## MAIN HOUSE - FIRST FLOOR

### First Floor Proposed changes:

Proposed Change FF1 to Stair and Master bathroom

second floor

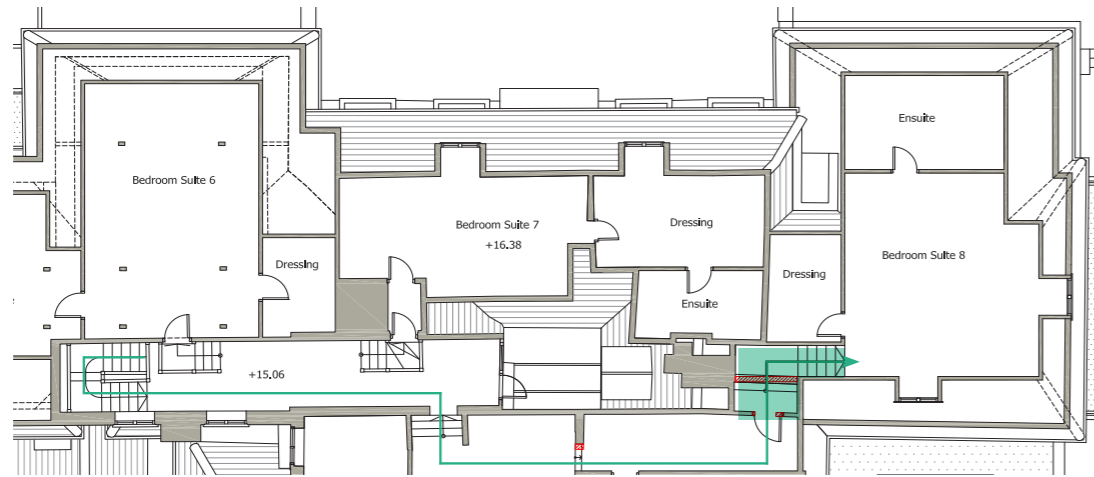
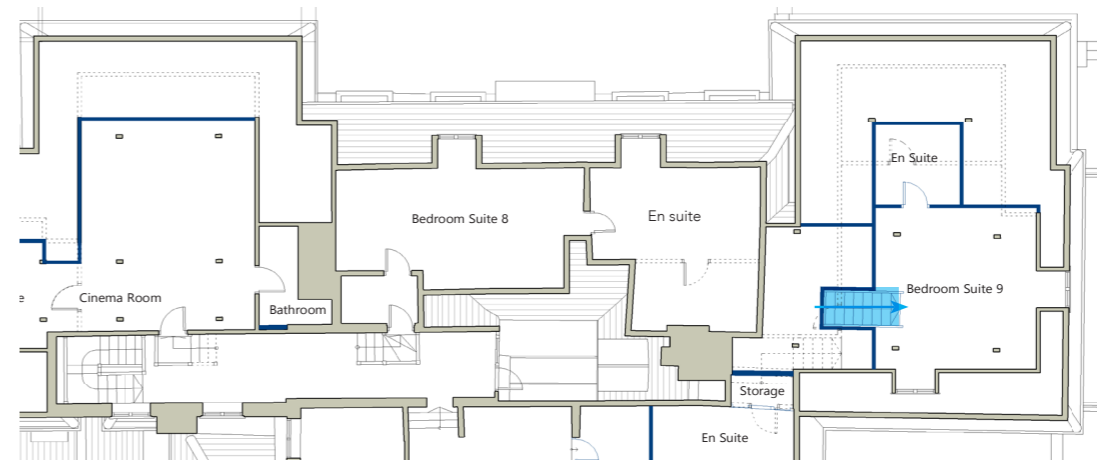
1.6m head height at stair landing. Very labyrinthine access.

2m head height at stair landing. Simplified access.

first floor

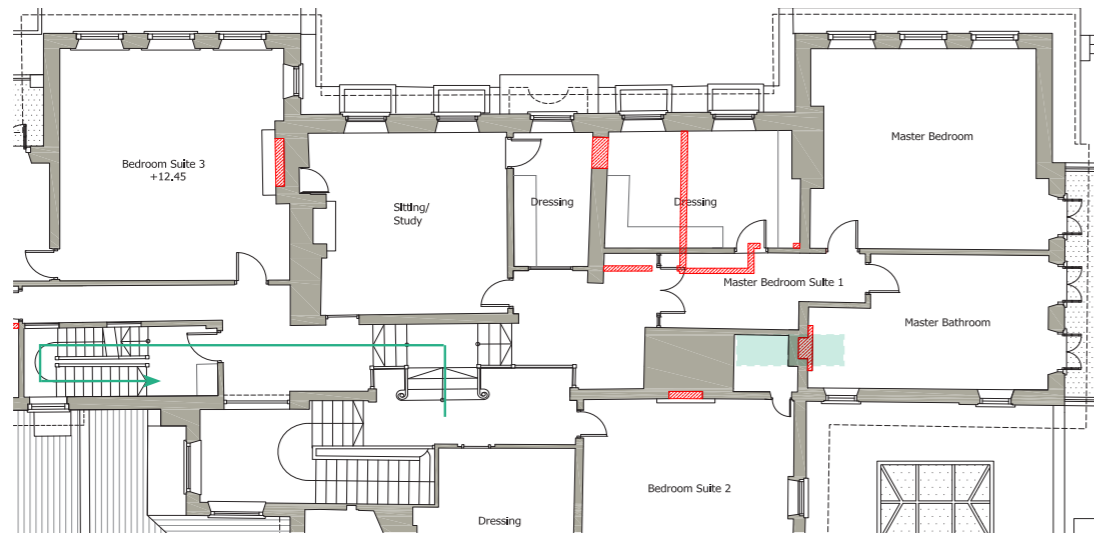
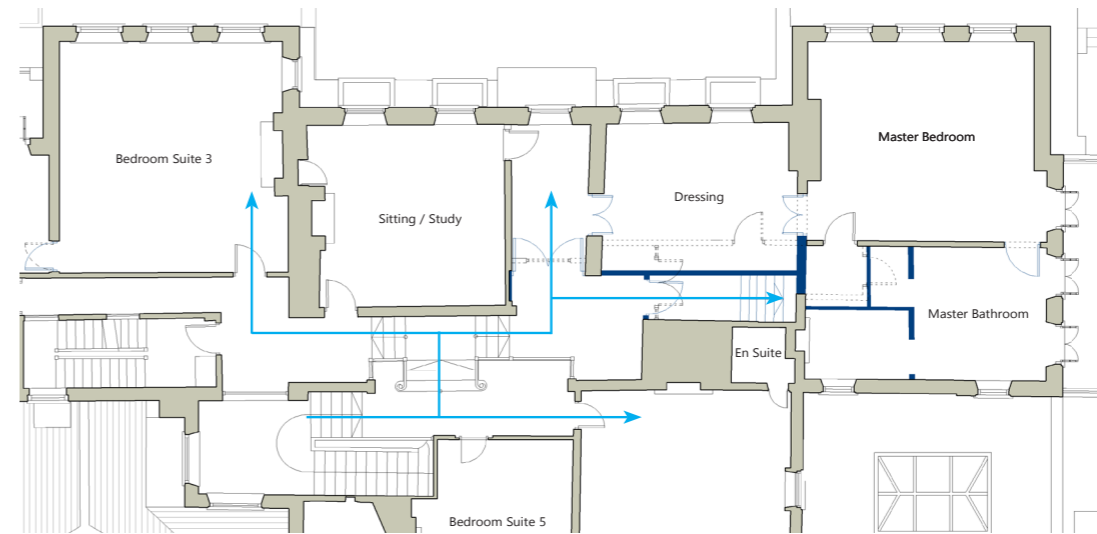
Underside of consented stairs will impact the chimney over the fireplace in master bathroom.

All main bedrooms accessible from main stair. New stair location does not impact fireplace.
